## Alternative Scheme Proposal:

The following alternative scheme proposal has been suggested by a respondent to the consultation:

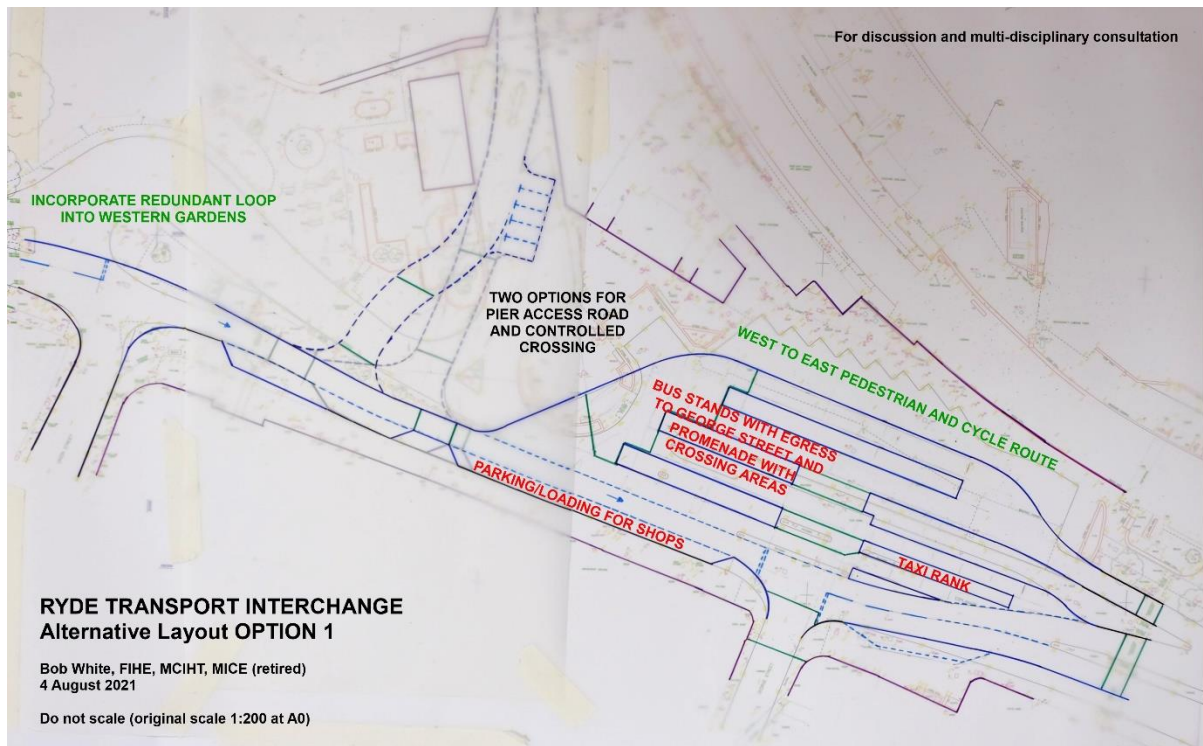
This option does not present a credible alternative or suggest any need for a fundamental review of the intended approach having a number of inherent weaknesses:

1. It modifies the Esplanade to one way traffic flow eastbound between Union Street and St George Street. As a consequence traffic approaching the pier from the east or travelling though to access the car parks in St Thomas Street would need to divert via either Dover Street or George Street, Melville Steet and Union Street. This would introduce additional vehicles movements into the town centre with the consequent implications for air pollution and road safety.

2. It does not provide sufficient bus stands to the west of George Street to allow services to exit directly to George Street and so avoid the diversion via the roundabout at Dover Street

3. It does not provide safe pedestrain routes to access either the bus bays served from the central island nor taxi rank.
4. It does not provide central islands of sufficient width to accommodate bus shelters and seating or scope for planting thereon.

5. It introduces 4 different exit points from the bus station / taxi rank to the Espanade with consequent scope for emerging vehicles to obstruct visibility.

6. It introduces an uncontrolled cross roads at the George Street junction with priority for buses leaving the bus station although visibility of / for these will be obstructed by buses waiting at the layby closest to the carriageway with no clear priority and scope for confusion / conflict between buses emerging from that layby and both eastbound traffic and buses emerging to access George Street

7. The comparatively few bus movements from the bus station to George Street and uninterrupted view of the road ahead for eastbound traffic is likely to lead to drivers not perceiving the junction / right of way for buses accessing George Street and lead to conflicts between those.

8. It introduces a curve in the west bound carriageway alignment on the approach to George Street making it impossible for vehicles emerging from the loading bay to see approaching traffic.

9. It retains the end on parking bays at the pier exit retaining the scope for conflict between vehicles leaving the pier and drivers emerging from the bays with limited visibility.

10. It removes the signal controlled crossing of the Esplanade immediately to the east of Union Street and provides an uncontrolled crossing further to the east which does not reflect the pedestrian desire lines from the interchange to access either Union Street or George Street.

11. This crossing although provided on a raised platform will not be perceived to provide priority for pedestrians resulting in pedestrian / vehicle conflicts

12. It retains the concrete block built café and toilet block which obstruct views both of and from the listed pier contrary to the aspirations of the Town Council, Business Association and Ryde Society expressed through the Regeneration Group
